Access Compliance Report

Public Rights-of-Way

(Curb Ramps)

Intersection ID: 10034961	Main Street: PROVIDENCE_RD_WEST	Cross Street: N/A	Location: SE
ADA ID: CCA1B5CC83ED	Ramp Type: PerpDiag	Initial Pass/Fail: Fail	Overall Compliance: No
Severity Score: 12.5			
Codes/Mitigation Info/Possible Solution		Field Measurements/Component Compliance

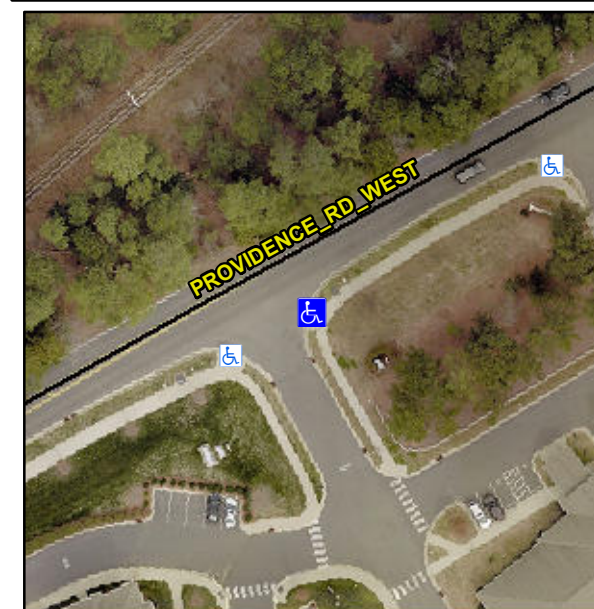
Remove & Replace Curb Ramp With Two New Directional Ramps or Equivalent.

R304.2.2

Compliance	Description	Data	Compliance	Description	Data
N/A	Ramp Length (in)	58.0	No	Ramp Slope (%)	11.1
Yes	Ramp Width (in)	48.0	Yes	Ramp XSlope (%)	1.3
N/A	Flare Type LT	N/A	N/A	Flare Type RT	N/A
N/A	Flare Slope LT (%)	N/A	N/A	Flare Slope RT (%)	N/A
N/A	Flare Traversable LT?	N/A	N/A	Flare Traversable RT?	N/A
N/A	Landing Length (in)	N/A	N/A	DWS Provided?	N/A
N/A	Landing Width (in)	N/A	N/A	DWS Contrast?	N/A
N/A	Landing Slope (%)	N/A	N/A	DWS Length (in)	N/A
N/A	Landing X Slope (%)	N/A	N/A	DWS Full Width?	N/A
N/A	Landing Curb? (Y/N)	N/A	N/A	DWS Offset (in)	N/A
N/A	Shared Landing?	N/A			
N/A	Gutter Ponding?	N/A	N/A	Gutter Slope (%)	N/A
N/A	Gutter Lip Ht (in)	N/A	N/A	Gutter X Slope (%)	N/A
N/A	Painted X Walk1?	No	N/A	Painted X Walk2?	No
	X Walk 1 Direction	To N		X Walk 2 Direction	To SW
N/A	X Walk 1 Width (in)	N/A	N/A	X Walk 2 Width (in)	N/A
	X Walk 1 Slope (%)	3.3		X Walk 2 Slope (%)	1.9
	X Walk 1 X Slope (%)	0.9		X Walk 2 X Slope (%)	0.6
